TRAFFIC OPERATIONS SYSTEMS (TOS)

MARK	DATE	DESCRIPTIONS	BY	CH'D	CCO#
4	10/10/08	LIGHTING REVISIONS	RY AG	RG FW	43
3	03/05/08	CABLE ELECTRICAL	RR AG	RG SE	72
2	02/25/08	CABLE TRAY CHANGES	RG	SE	42S1
1	02/19/08	ELECTRICAL MODIFICATIONS	MP EL	RR	42

CONTRACT CHANGE ORDER NO. 43 SO
SHEET 4 OF 42

CONDUIT PLAN

480 V LIGHTING POLE

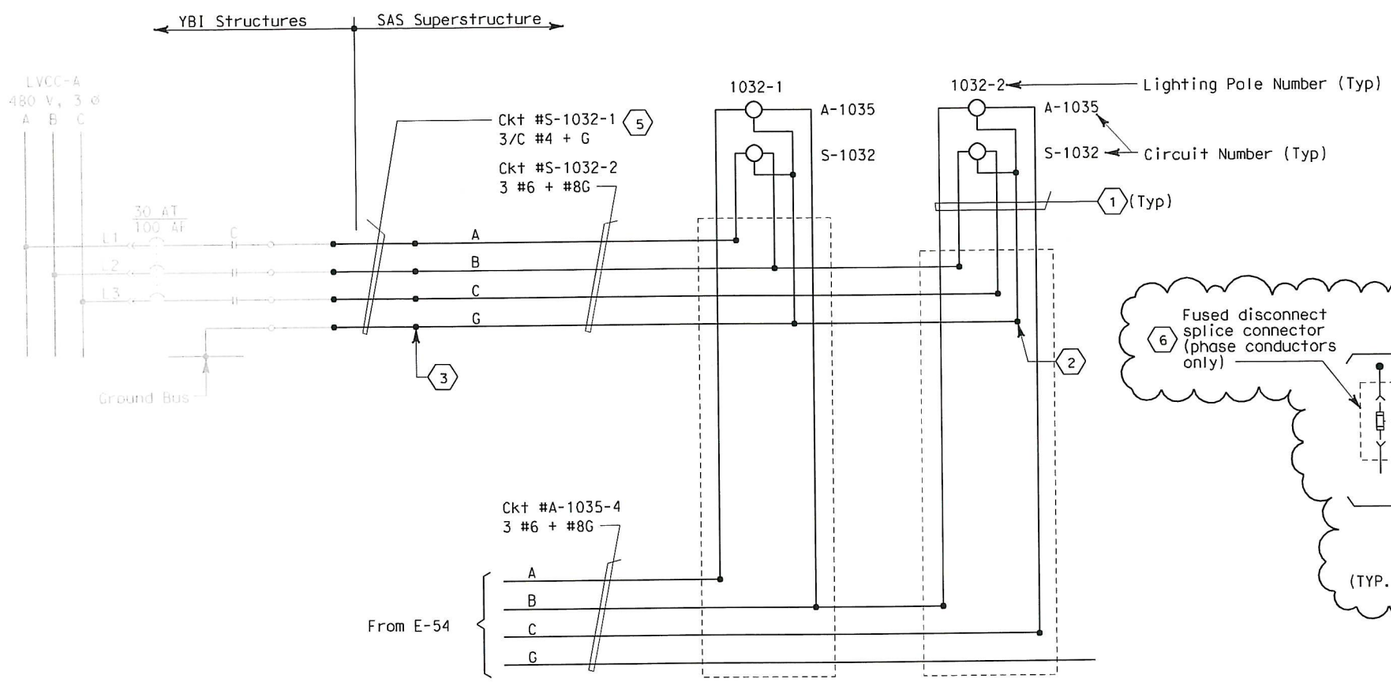
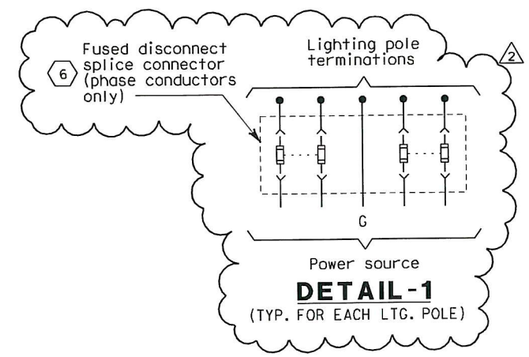
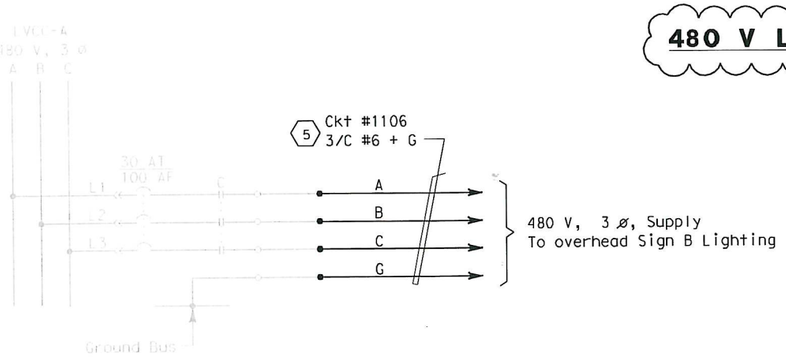
1. 4#10 + #10 G single conductors. See Detail 1.
2. Conductors spliced inside pull box PB-LTG. (Pole #1032-2 only).
3. Conductors spliced inside junction box PB-2A located inside girder.
4. For SAS superstructure roadway westbound lighting schedule, see sheet E-82.
5. The Contractor shall extend and coil 5 meters of cable in manhole 25. All cables shall be tagged with circuit numbers as shown. For location of manhole 25, see sheet E-11.
6. Install 10A (ckt S-1032) and 5A (ckt A-1035) in-line fuse inside each light pole.

CONDUIT STUB-UP PLAN FOR ROADWAY LIGHTING ON A METAL BASE (SIMILAR FOR OVERHEAD SIGN ON A METAL BASE EXCEPT AS NOTED)
SCALE 1:20

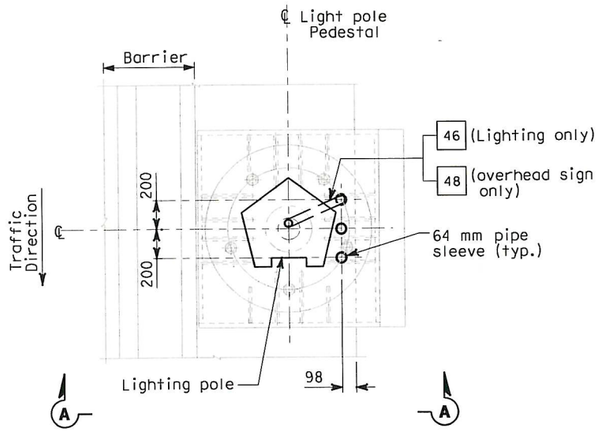
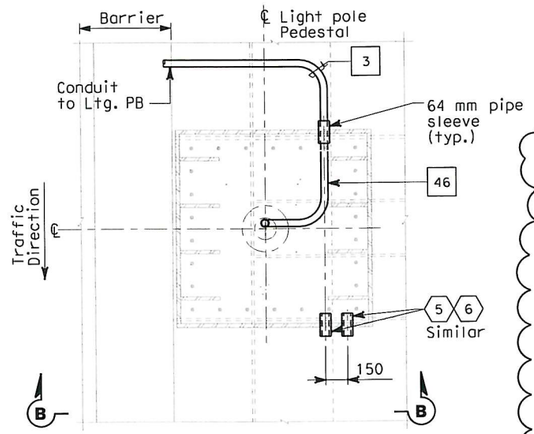
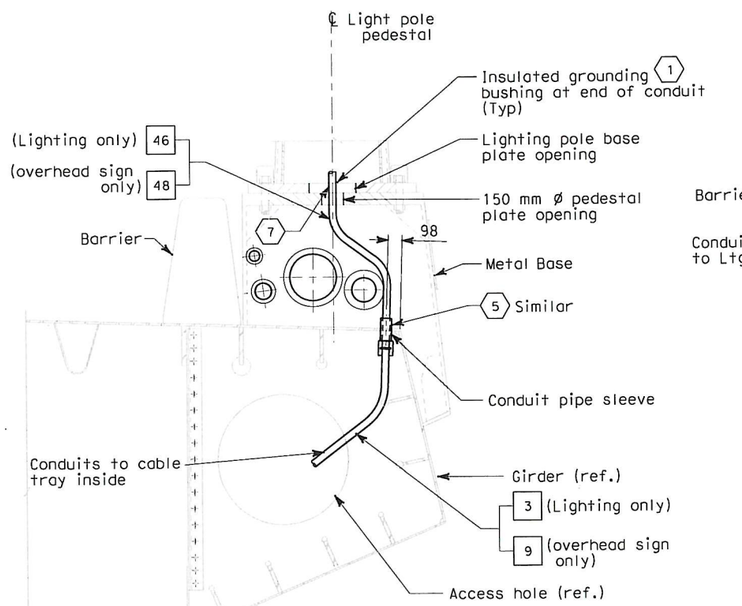
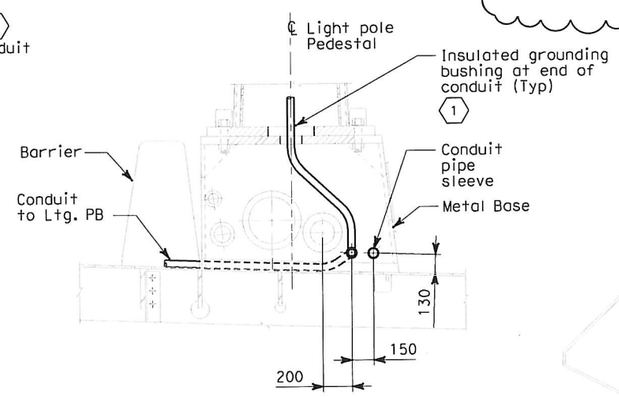
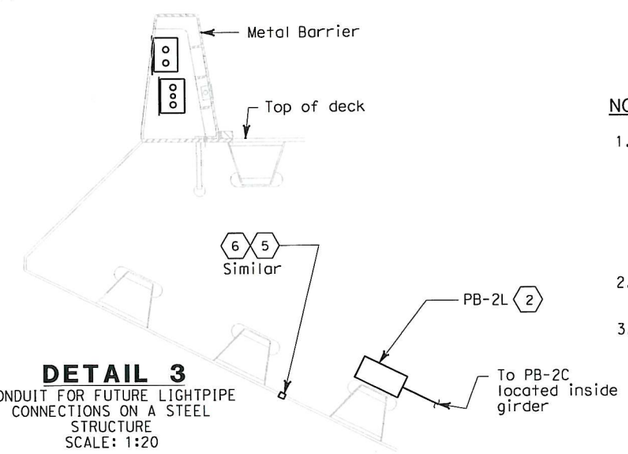
1. Bond grounding bushing to ground lug of lighting pole with #6 bare copper wire.
2. Conduits for future light pipe shall continue from this pull box.
3. Deleted. 4
4. Deleted.
5. See Utility Detail No. 1 (Sheet No. 965 of 1204) for conduit penetration through girder plate and lighting pole metal base. The Contractor shall install sealant between the sleeve and conduit to prevent water or moisture from passing inside the sleeve.
6. Cap spare sleeves for future use where noted.
7. Ensure that the maximum of three conduits passing through the 150 mm ø pedestal plate opening are separated as much as possible from each other.

480 V LIGHTING POLE 2

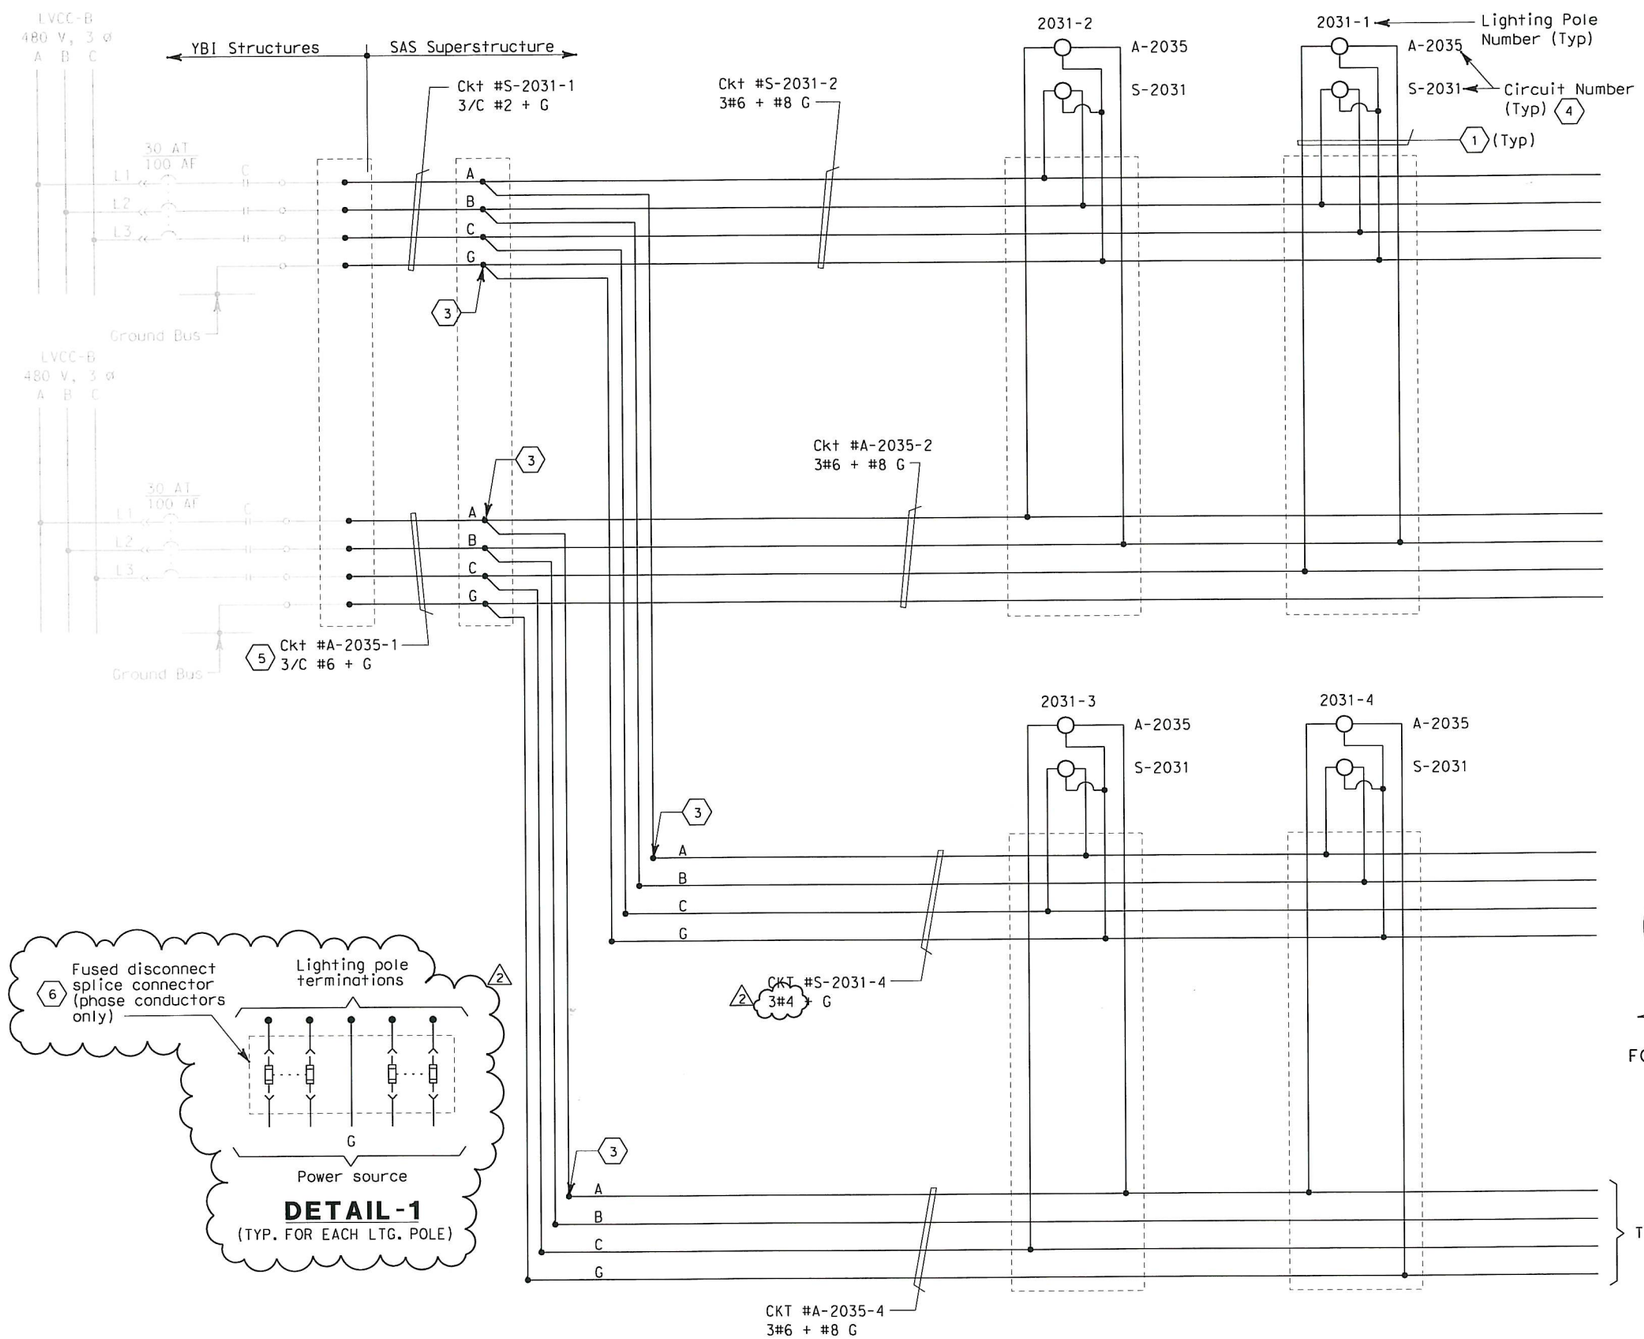
1. ~~#10 or #10 G~~ single conductors. See Detail 1. 2
2. Deleted.
3. Conductors spliced inside junction box located inside girder.
4. For Main Span Roadway Eastbound lighting schedule, see sheet E-168.
5. The Contractor shall extend and coil 5 meters of cable in manhole 25. All cables shall be tagged with circuit numbers as shown.
6. 2 Install 10A (ckt S-2031) and 5A (ckt A-2035) in-line fuse inside each light pole.
